FINAL DRAINAGE REPORT
HANNAH RIDGE AT FEATHERGRASS
FILINGS 5, 6 & 7

October 2018

Job no. 1116.05

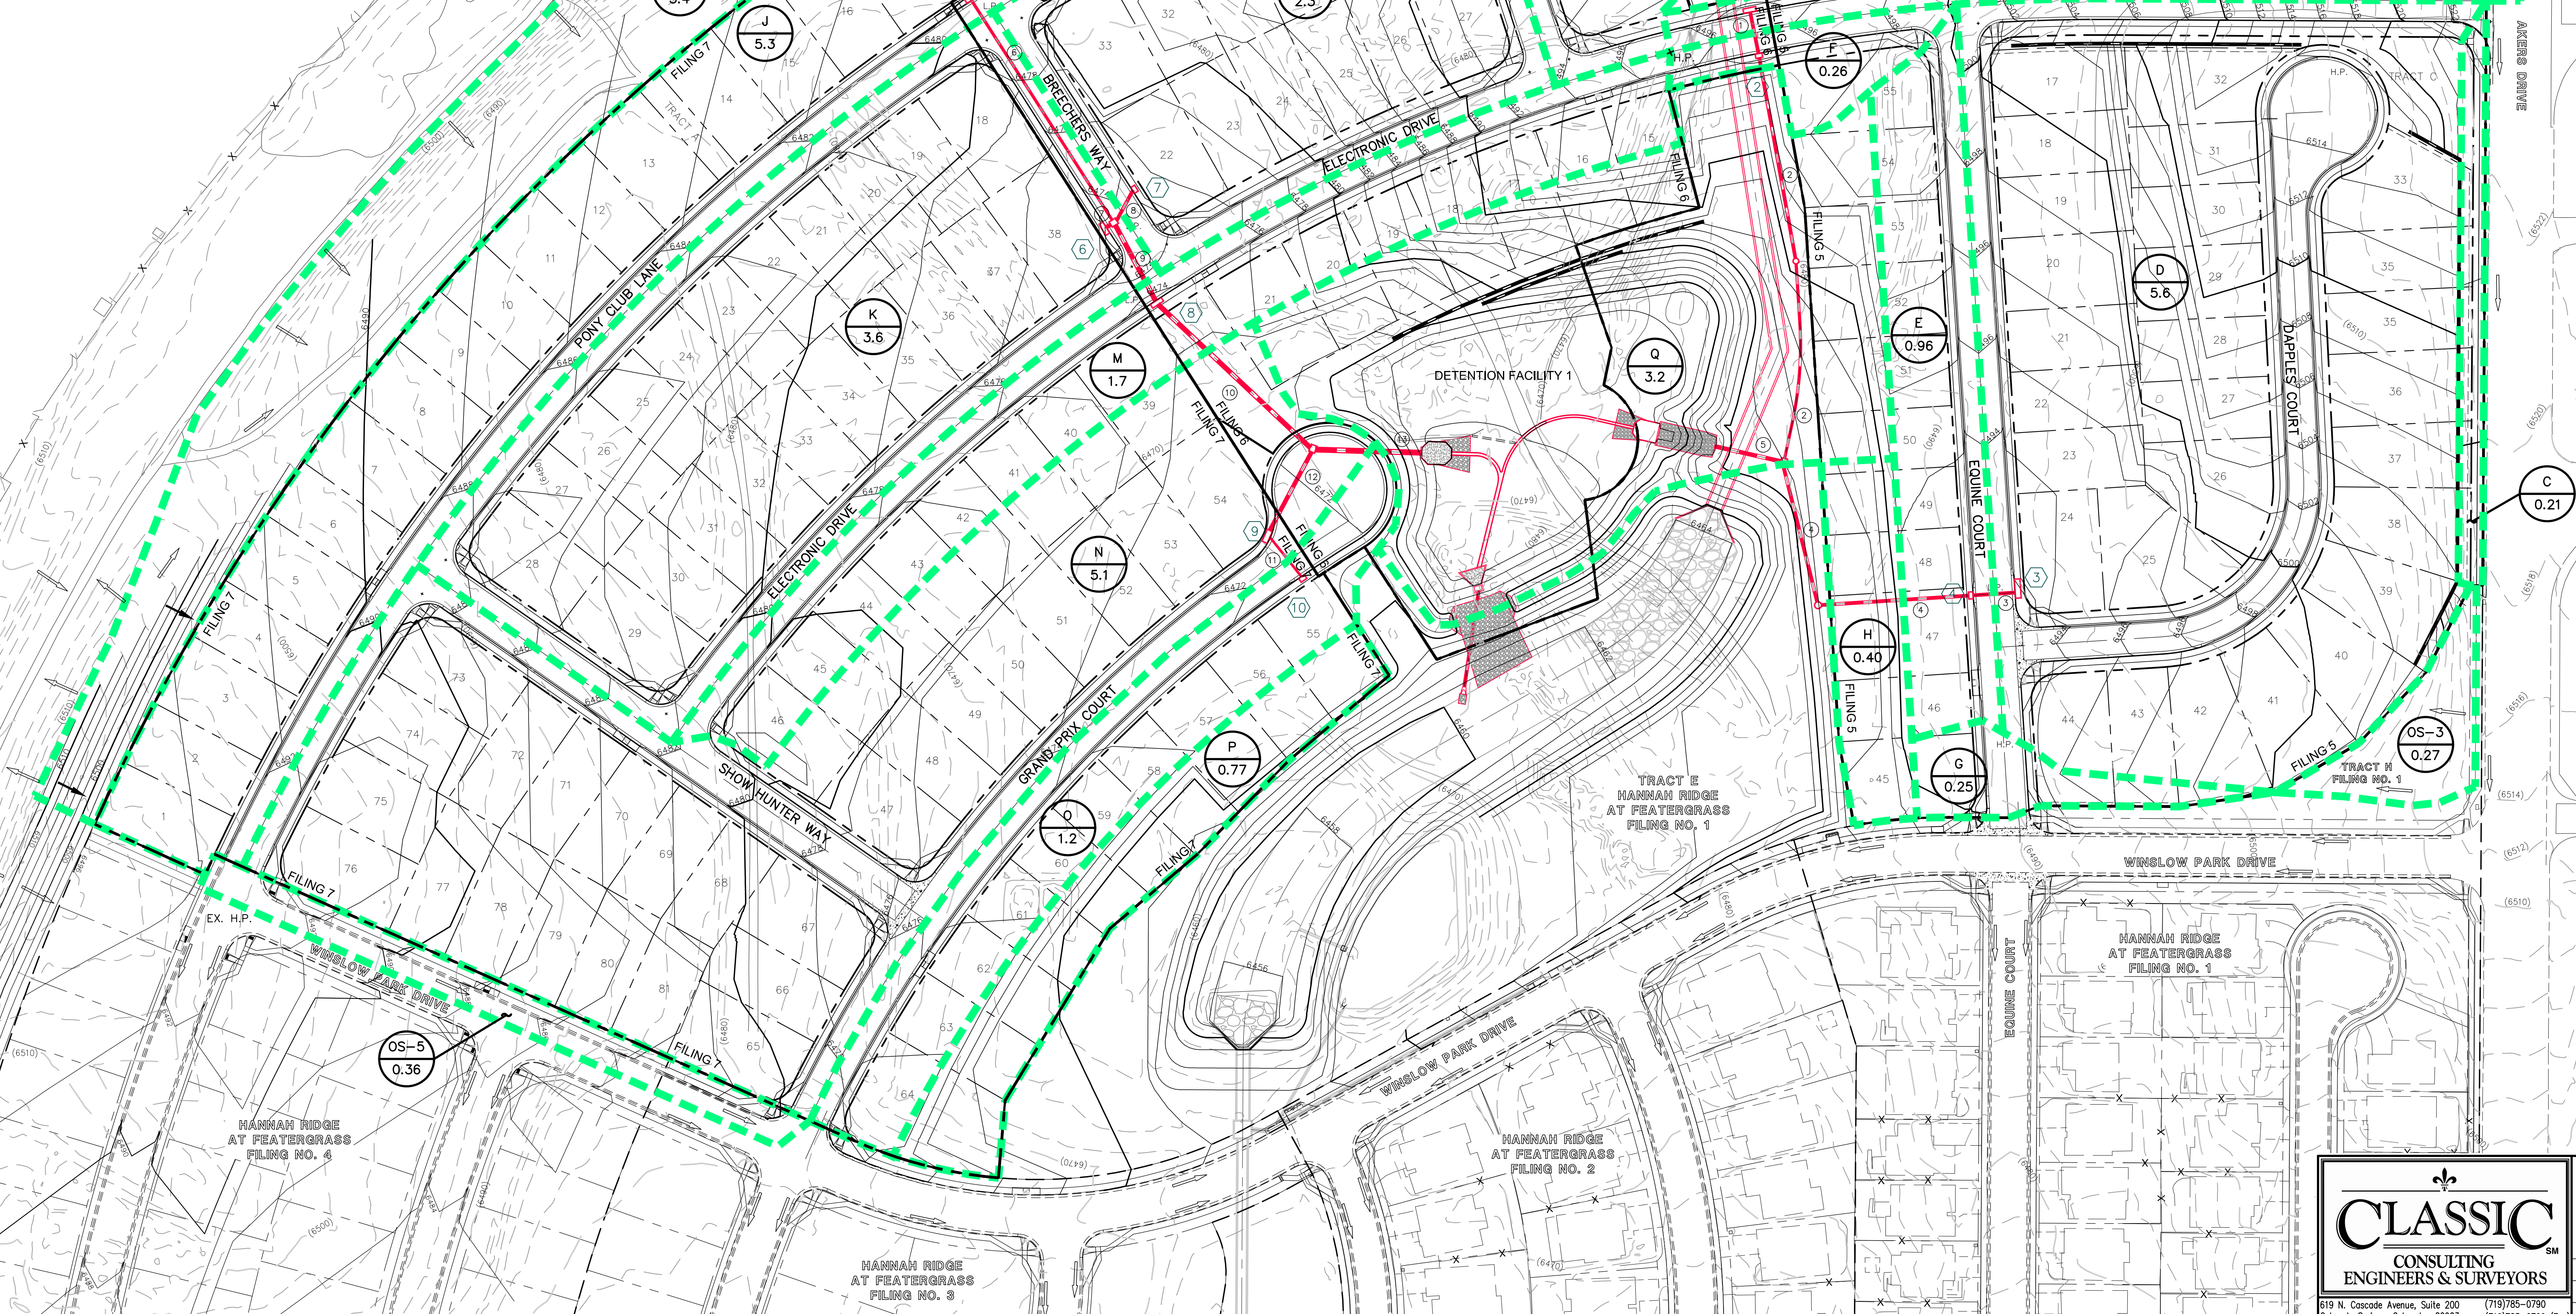
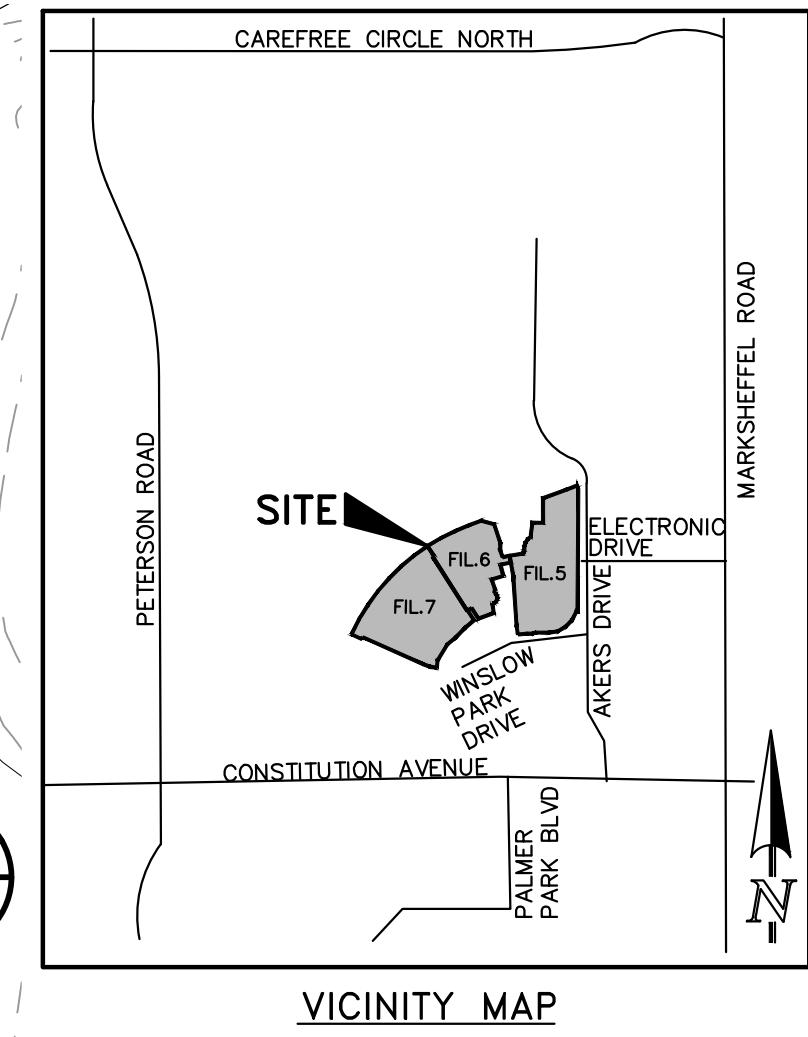
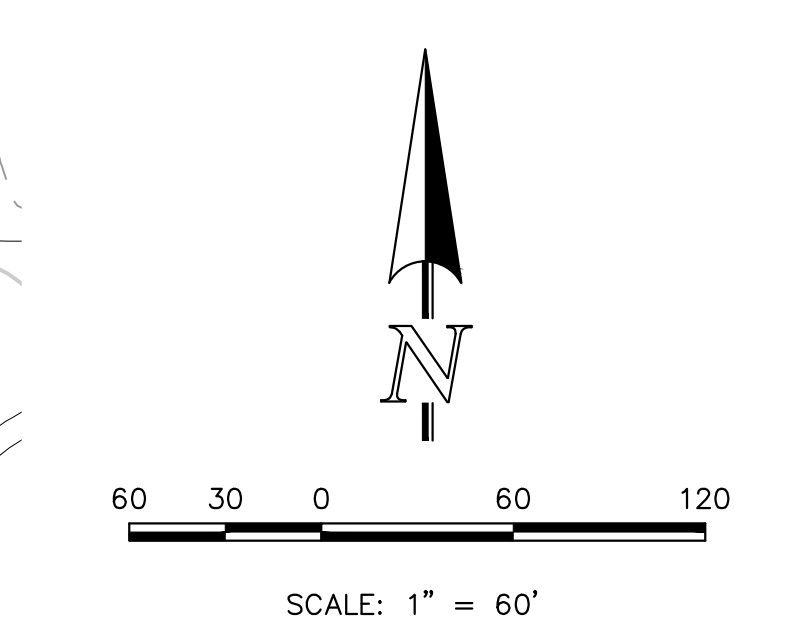
There needs to be less than one acre of development area that does not receive WQCV. With this 0.80 acre piece and other areas such as Basin G, this development (Filings 5, 6 & 7) does not meet this criteria. Please route this area so it receives WQCV or provide its own WQCV Facility.

There needs to be less than one acre of development area that does not receive WQCV. With this 0.80 acre piece and other areas such a Basin G, this development (Filings 5,6 &7) does not meet this criteria. Please route this area so it receives WQCV or provide its own WQCV Facility. Or adjust the overall plan accordingly.

There needs to be less than one acre of development area that does not receive WQCV. With this 0.80 acre piece and other areas such a Basin G, this development (Filings 5,6 &7) does not meet this criteria. Please route this area so it receives WQCV or provide its own WQCV Facility.
